Nuclear Risk Report

Material Problems in Reactor Pressure Vessels: Doel 3/Tihange 2

The Safety Cases performed by the licensee as a consequence of the detection of thousands of flaws in the reactor pressure vessels in Doel 3 and Tihange 2 were analyzed, the deficiencies of the structural assessment in the safety case reports published by the Belgian Nuclear Authority FANC were identified and discussed. There exist considerable doubts on the Safety Cases as accepted by FANC with respect to the methodology concerning number, size and origin/ nature of the flaws, the radiation embrittlement trend curves and the performed structural integrity assessment for the reactor pressure vessels.

Figure 3: Trend curves for shift of reference temperature RT_{NDT}

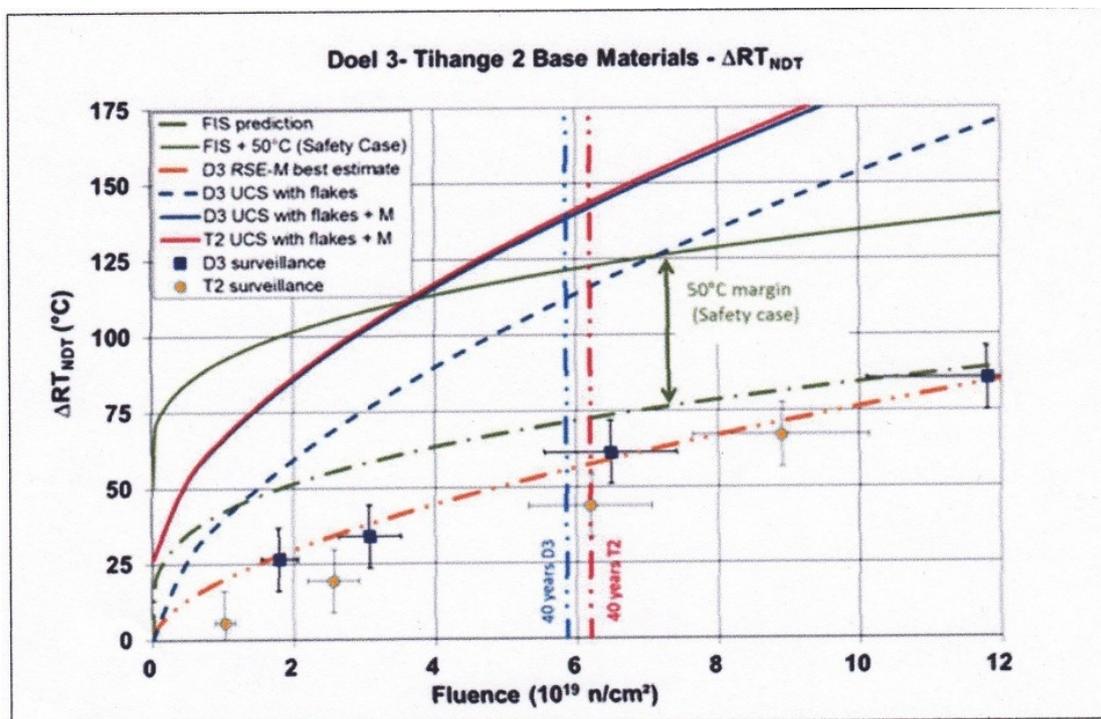
At first sight the new trend curves seem to be more conservative than the former FIS curves in the end-of-life fluence range. But since the fluence at the position of the flaws within the RPV wall is lower than at the inner surface of the wall the lower frequency range ($3-4 \times 10^{19} \text{ n/cm}^2$) is relevant³³.

The lowest curve is the new trend curve without standard deviations (average value through surveillance program data). The curve above (dotted green) is the old FIS curve showing to be an envelope with respect to the surveillance data. The green curve is the FIS curve + 50°C as proposed in the Safety Case 2012. The red-blue curve is the new trend curve including the standard deviation margins (in the range of $3-4 \times 10^{19} \text{ n/cm}^2$ the new trend curve is less conservative than the trend curves as proposed in the Safety Case 2012). Source: Electrabel Safety Case 2015³⁴

Figure 4: Temperature at 41 J in comparison to Tihange 2 core shell experimental data sheets

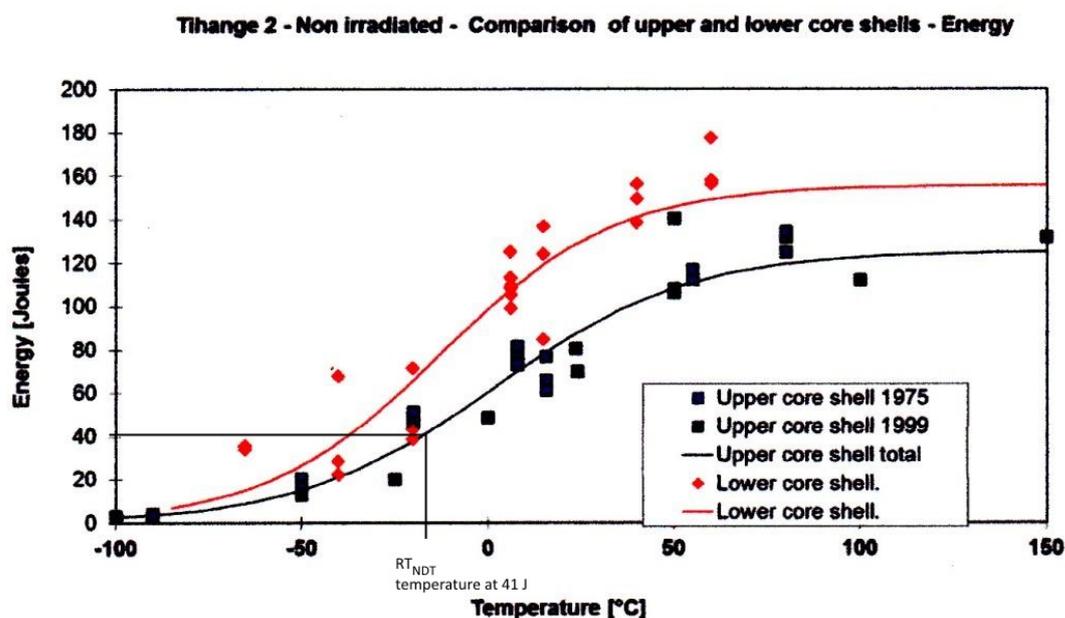
Comparing the RT_{NDT} values for the initial (unirradiated) state of the base metal as used by Oak Ridge National Laboratory - ORNL (table 3) with experimental data sheets³⁸ for Tihange 2 upper core shell (black curve in figure 4) the following can be observed:

The figure shows that $RT_{\text{NDT(Init)}}$ for the upper core shell cannot be $-25,4^{\circ}\text{C}$. The figure also shows that there is a large scatter of the experimental data so that the reduction of the standard deviation for $RT_{\text{NDT(Init)}}$ to zero is not justified. Both facts indicate that it is doubtful that the PTS screening criterion is met.

Figure 5: Fracture toughness curve

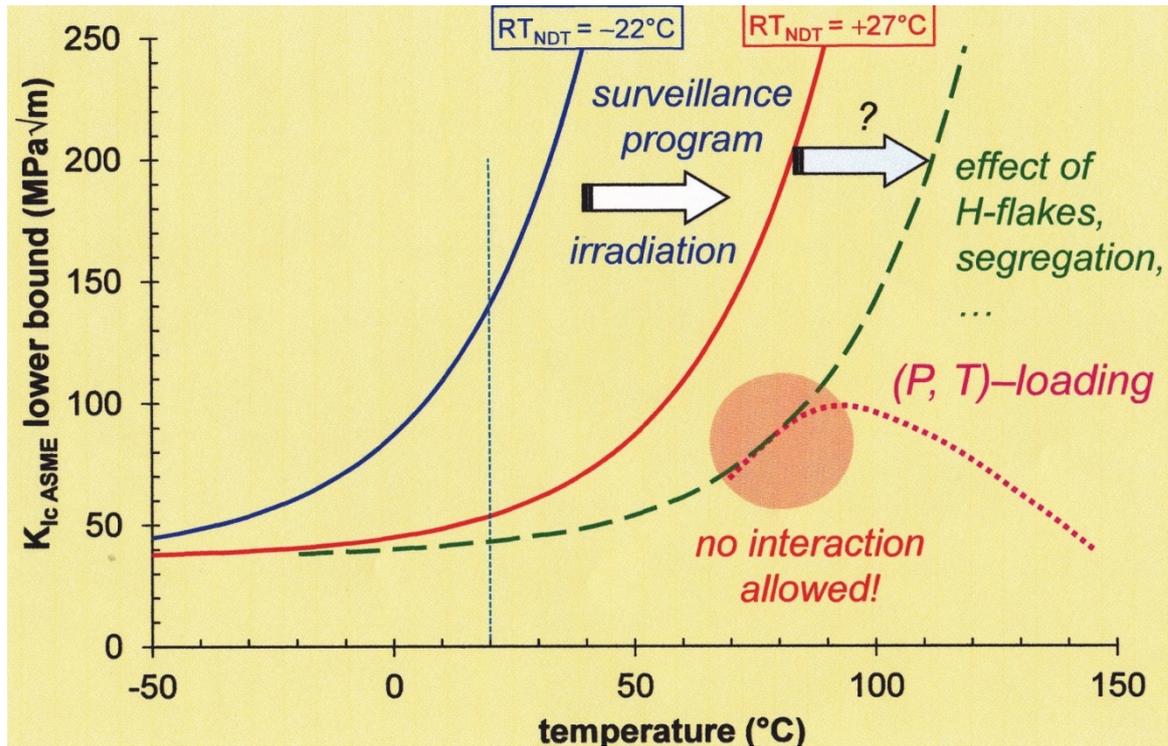
Comparing the calculated load path (stress intensity versus temperature during the accidental transient) with the lower bound fracture toughness curve the tangency of the two curves gives the critical RT_{NDT} . This critical value may not be reached until end of life. This is the so called ASME acceptance criterion:

ORNL followed another strategy applying the so called warm prestress (WPS) effect. The application of the WPS effect in the PTS analysis is allowed in the US Regulatory environment but not in the French standard. As the above figure indicates (“no interaction allowed”) the application of the WPS effect is also not allowed in Belgium. It is not clear why ORNL nevertheless has adopted the WPS effect for its safety margin assessment.

Figure 6: Fracture toughness curve and WPS effect

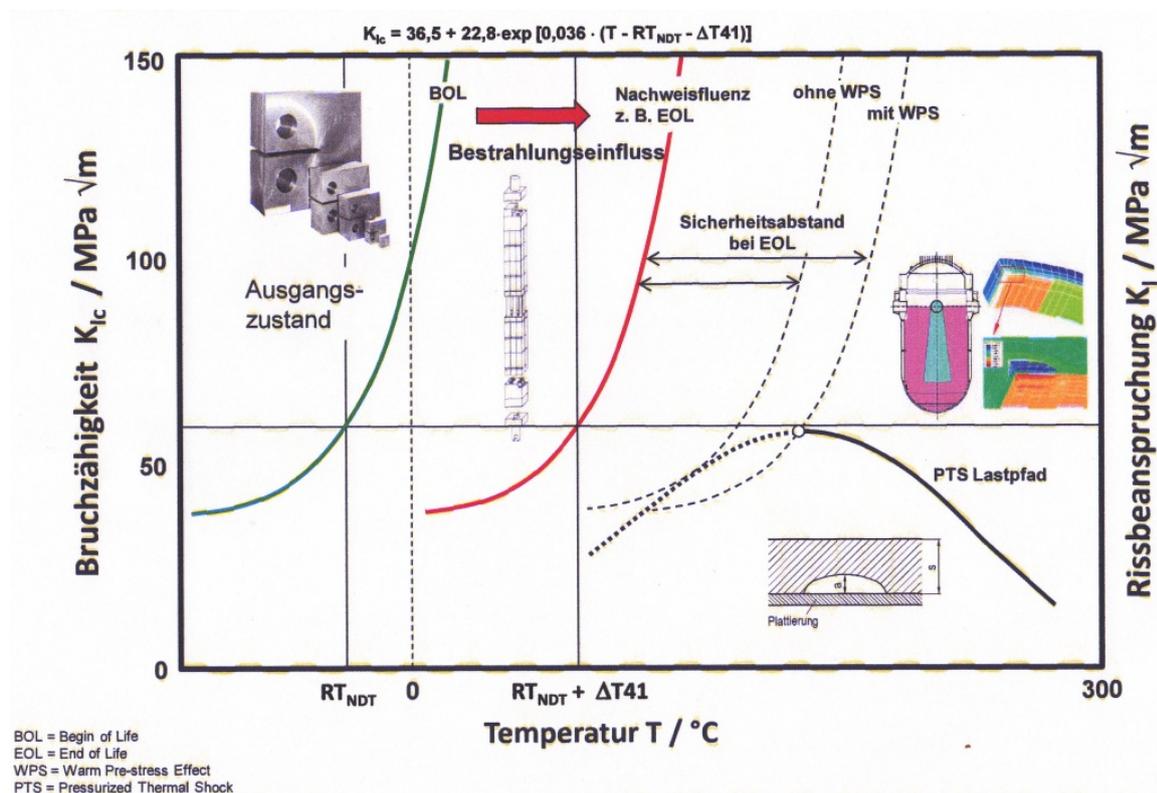
The application of the WPS effect means that the tangency of the load path with the fracture toughness curve occurs after the reaching the maximum of the load path as can be seen in the figure 6.

Nevertheless, the ORNL calculations including the WPS effect could not show compliance for all flaws. For the flaw #1660 (Tihange 2) ORNL finally adopted also a 3D-XFEM approach (“*more realistic modeling*”) to reach compliance.
